**DRAFT FOR PUBLIC COMMENT
EXPLANATION OF SIGNIFICANT DIFFERENCES
PINE STREET CANAL SUPERFUND SITE
BURLINGTON, VERMONT
December 2008**

Site Name: Pine Street Canal Superfund Site
Site Location: Burlington, Vermont
Lead Agency: United States Environmental Protection Agency (EPA)
Support Agency: Vermont Department of Environmental Conservation (VT DEC)

FIGURE
 1-2

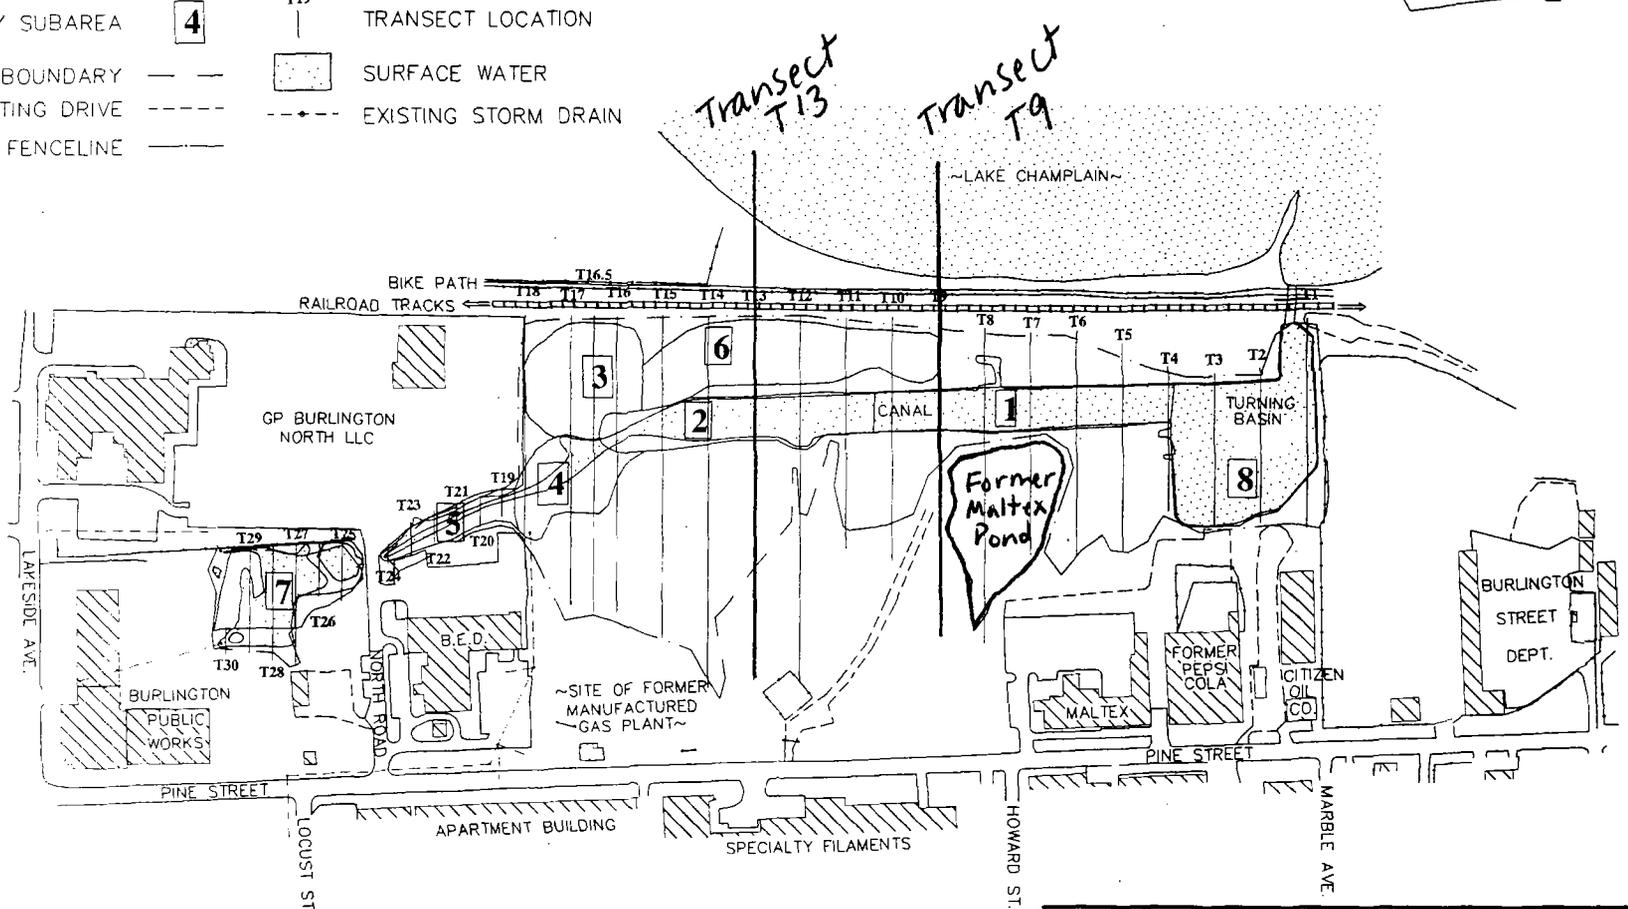
This draft ESD calls for a modification of the cap to address the ongoing migration of NAPL. In areas where NAPL is seeping (between transects T9 and T13 approximately, as shown on figure 1), the cap will be partially replaced and/or augmented with a new cap system that will capture NAPL before it is released into the canal. The NAPL that accumulates will periodically be removed and shipped off site for treatment or disposal in an approved facility.

In those areas where the seepage of contaminants is occurring (between transects T9 and T13, approximately), this ESD provides that the existing cap will be redesigned and reconfigured to intercept and sequester the NAPL, preventing its release into the canal. The specifications for the new cap profile and the selection of materials for the cap will be finalized during design. It is expected that the new cap will include a high-permeability layer that will reduce the gas gradient and will facilitate passive collection and removal of NAPL. In addition to the performance standards for the isolation of contaminants set forth in the 2000 Consent Decree¹, the new cap will be evaluated against the following design criteria:

One possible design for the reconfigured cap is described as “Alternative 2” in the June 2008 *Final NAPL Controls Report*. Alternative 2 would modify the existing cap between T9 and T13, approximately, with the addition of two new layers. The first would be a comprised of high-permeability, lightweight material (e.g., pumice, expanded perlite, recycled glass) in which slotted pipes would be laid to facilitate NAPL capture and removal. This layer would be covered with a reactive cap in which an absorbent material (e.g., organoclay) at the core of the cap binds with the contaminant and prevents its release. When the capacity of the absorbent material is reached, the reactive cap must be replaced. However, it is expected that most of the migrating NAPL would accumulate in the underlying high-permeability layer before it reached the reactive cap, thereby minimizing the need for change-out. The new cap with its NAPL capture layer would require a more complex operation and maintenance program than did the original sand cap.
